Bradfield Park Central Cycle Ramp Review

Transport for NSW

14/03/2022

30119208

Figure 2 Austroads Guide to Road Design recommended gradients for cycling infrastructure

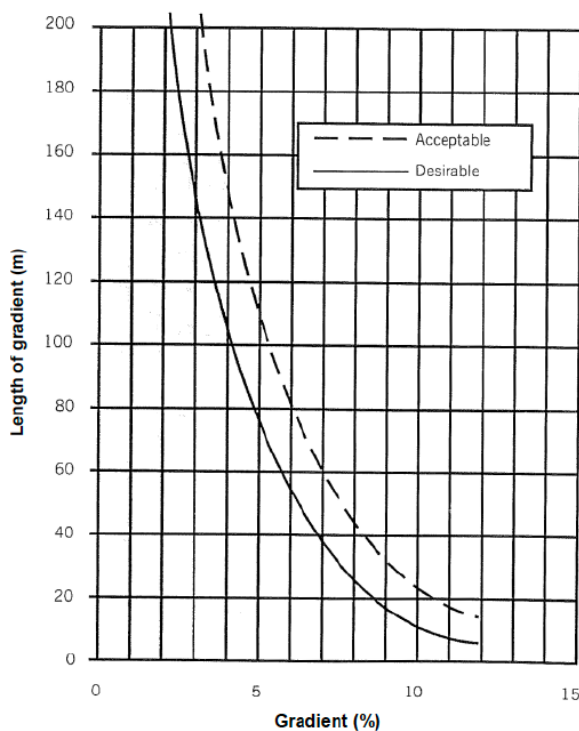
For example, in regard to the ramp's gradients, Barros van den Dool mentions that the Austroads guidelines state "In general, the 'acceptable' line in the figure would be satisfactory for paths with a high proportion of regular or physically fit riders, which in most instances would include commuter and sporting riders. Otherwise, the 'desirable' line in the figure is recommended." (this refers to the graph on Figure 2). This illustrates how the design recommendations of the Austroads Guide to Road Design tends to favour fit commuters and sporting riders over designing for all ages and abilities.

TfNSW aims for a transport system that is customer-focussed and, in this particular case, the future customers will be more diverse than commuter and sporting riders only as the bridge becomes accessible to a wider-range of bicycle users, as shown on Figure 2, and call for preferably compliance to the “desirable” side of the Austroads guidelines which is closer aligned with the CROW guide (see Figure 4).

Figure 4 Recommended ramp grades based on height differences, source: ipv Delft. Brief Dutch Design Manual for Bicycle and Pedestrian Bridges. English summary of the CROW design guide. June 2015, page 27

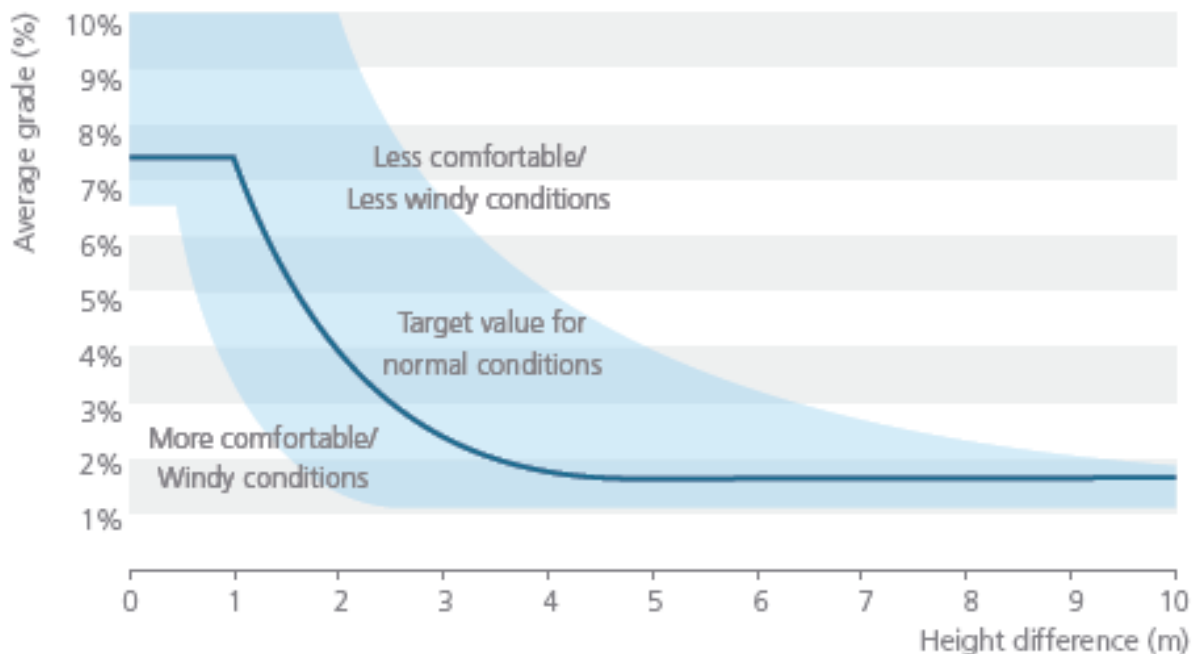
With a height difference of 8.8m, the proposed average slope of this ramp is 4.8%. This is way beyond the upper limit of 2.2% as defined by the *CROW Design Guide*⁶ and shown on Figure 3 (this document is also quoted by Barros van den Dool in their review and considered a reference for global design best practice).
